IBC - General

2016 GROUP B PUBLIC COMMENT AGENDA

OCTOBER 19 - OCTOBER 25, 2016
KANSAS CITY CONVENTION CENTER
KANSAS CITY, MO

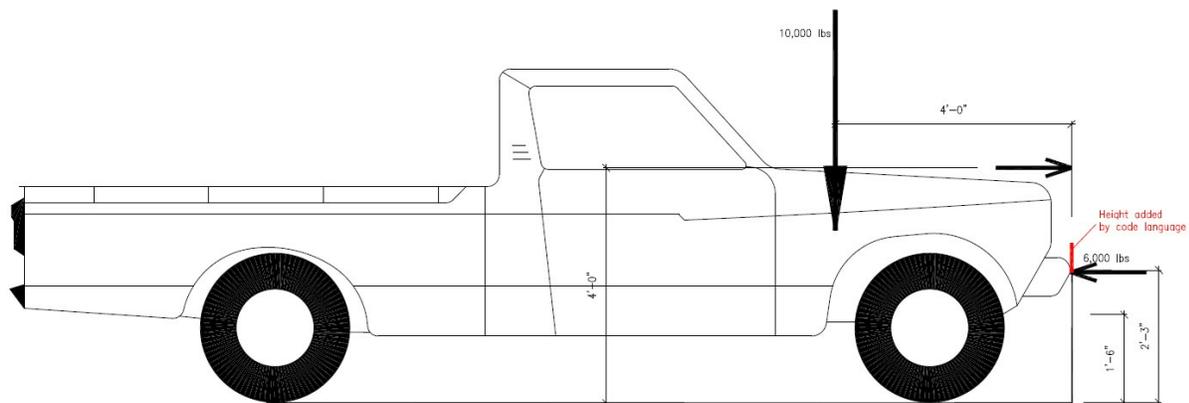
It is necessary first to consider the physics of the problem. A passenger vehicle weighing 3,000 lbs. (see figure below) has a low center of gravity. If the motor and vehicle weight were 12 in. above the bumper, and the vehicle imposed the code-required 6,000 lb load on the barrier, the moment would be

6 kips x 1 ft = 6 ft-kips. If the center of gravity were only 3 ft behind the bumper, the resistance to overturning would be 3 kips x 3 ft = 9 ft-kips. It is likely that the center is much further back.

This is an unrealistically conservative comparison of overturning at 27 in. of impact height with gravity resistance to overturning. It still would not flip the vehicle over the barrier. Actually the center of gravity of the vehicle is closer to 6 ft from the front end, and impact height is below the 27 in. maximum height in a typical passenger vehicle.
